# Service Update

## N242451390 First Responder Emergency Cut Loop Label Removal

**Revision:** 02

Subject: REVISION: N242451390-02 – Service Update  
First Responder Emergency Cut Loop Label Removal  
Revised Warranty, Service Procedure sections

6819098

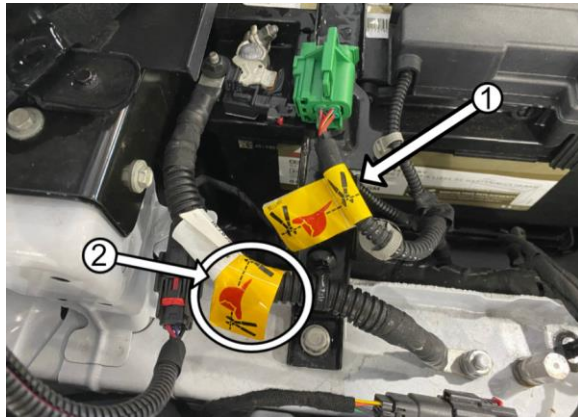
**Note:** GMC Hummer shown.

2. Inspect the High Voltage Service Lockout Harness for an Emergency Cut Loop label (1):
  - a. If the High Voltage Service Lockout Harness has an Emergency Cut Loop label applied (1), it PASSES inspection. Proceed to Step 3.
  - b. If the High Voltage Service Lockout Harness DOES NOT have an Emergency Cut Loop label (1) applied, it FAILS inspection. Claim "*High Voltage Service Lockout Harness Failed Inspection*" Labor Code after completion of the field action. Proceed to Step 3.
3. Inspect the 12V Battery Negative Cable for an Emergency Cut Loop label (2):
  - a. If the 12V Battery Negative Cable has an Emergency Cut Loop label (2) applied, it FAILS inspection. Proceed to Step 4.

4. Using a sharp cutting tool, remove the Emergency Cut Loop label (2) from the 12V Battery Negative Cable.
5. Install the Right Front Compartment Rear Sight Shield. Refer to *Front Compartment Rear Sight Shield Replacement - Right Side* in SI.

6819099

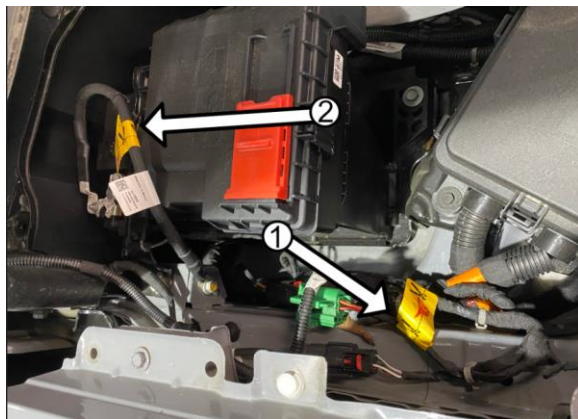
**Note:** Chevrolet Silverado EV shown. Also applies to GMC Sierra EV.

6819100

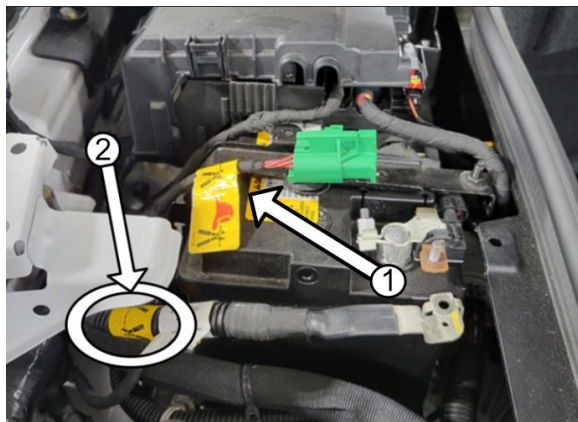
**Note:** Cadillac Escalade IQ shown.
